## **SOUTHWEST RESEARCH AND INFORMATION CENTER**

RE: Public Notice 20-03 - Draft New Shaft and Associated Connecting Drifts Permit

Southwest Research and Information Center (SRIC) provides the following comments on the draft Permit Modification, dated June 12, 2020. SRIC's comments in the Administrative Record (AR) regarding the new shaft are incorporated by reference and must be fully considered and responded to.

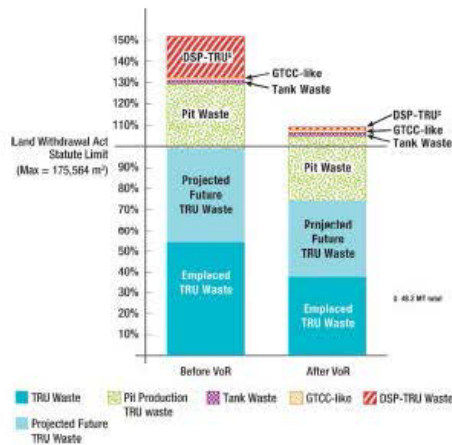
Figure S-5 of that NAS document shows current and proposed volumes of waste, using both the Land Withdrawal Act (LWA) and Volume of Record (VOR) volumes. The graphic shows that the proposed waste streams vastly exceed the LWA volume limits and exceed the VOR limits.

**Figure 2-4**  
**Plan View of WIPP Underground Facility**  
 (655 meters [2,150 feet] below ground level)

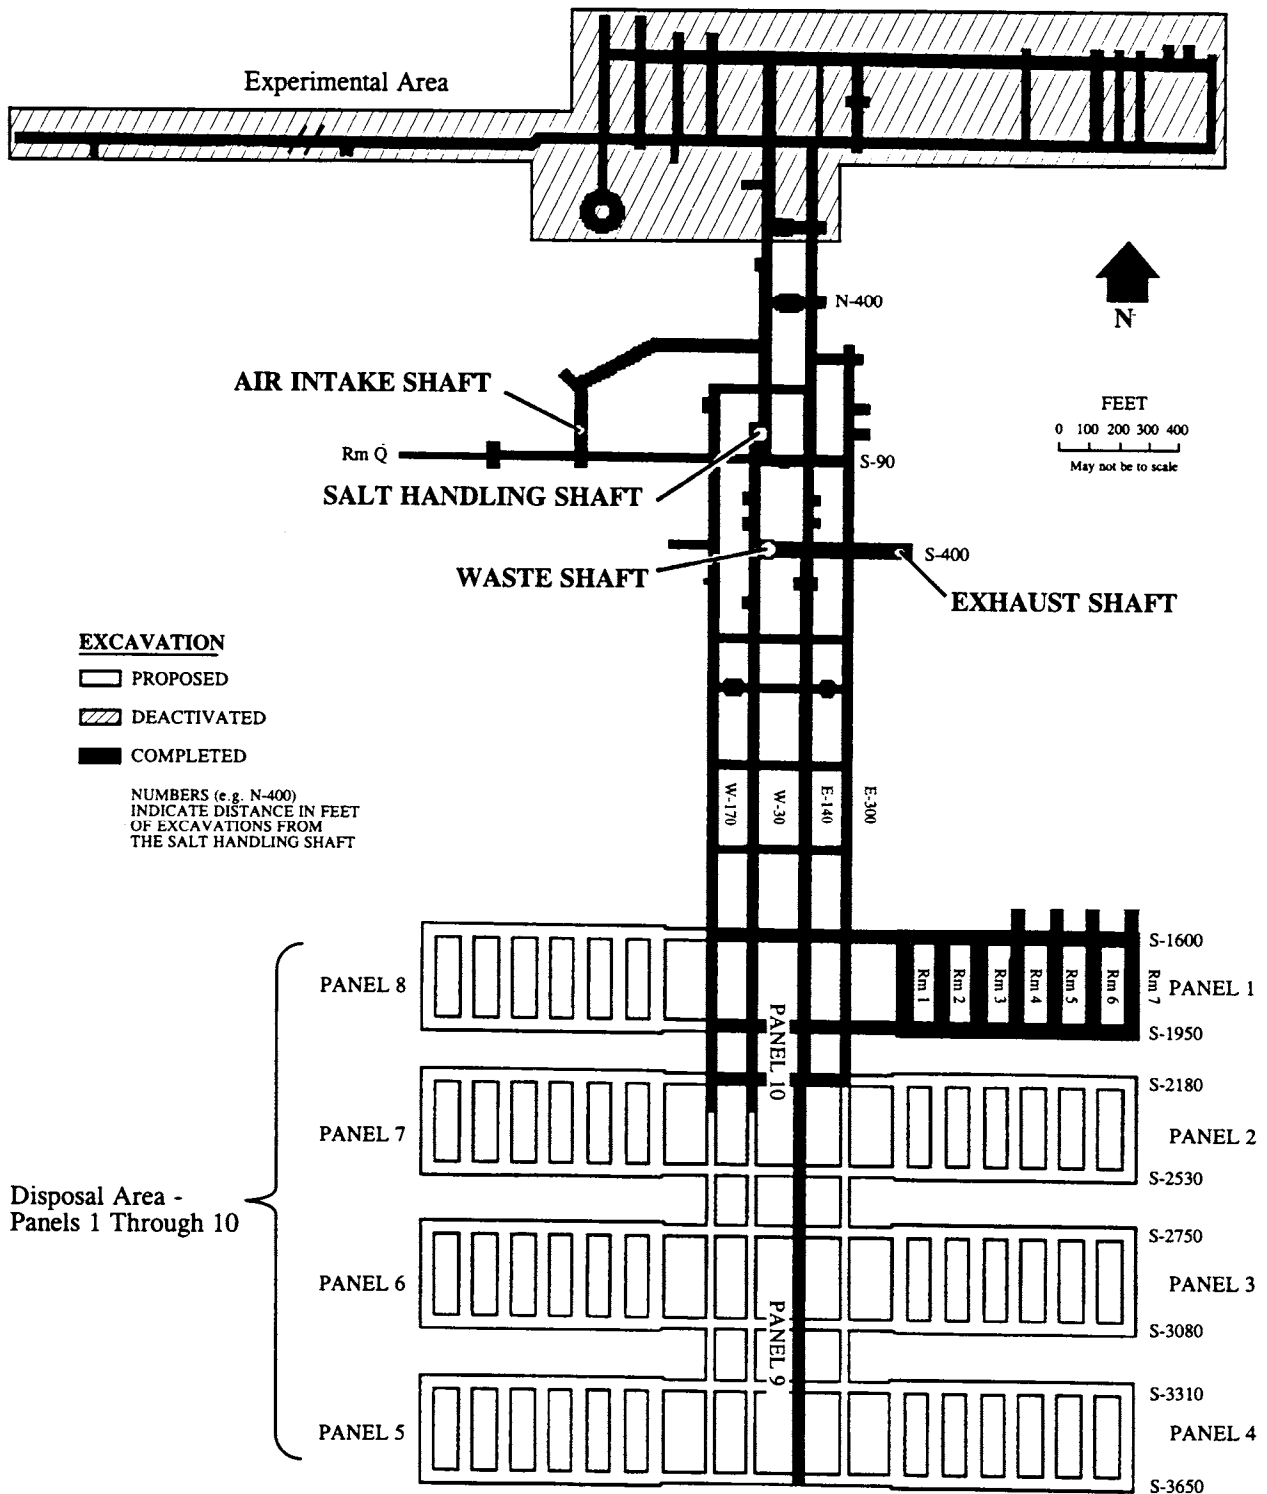
The SA is inadequate and incomplete to provide legally required NEPA analysis of WIPP expansion alternatives, including the new shaft and new underground footprint. That the new shaft is not needed for operation of the ten-panel underground footprint and is not included in WIPP NEPA documents is further demonstrated by the most recent WIPP Environmental Impact Statement (SEIS-II) in 1997 that includes the ten-panel underground footprint, without shaft #5 or additional panels.<sup>13</sup> See attached Figure 2-4.
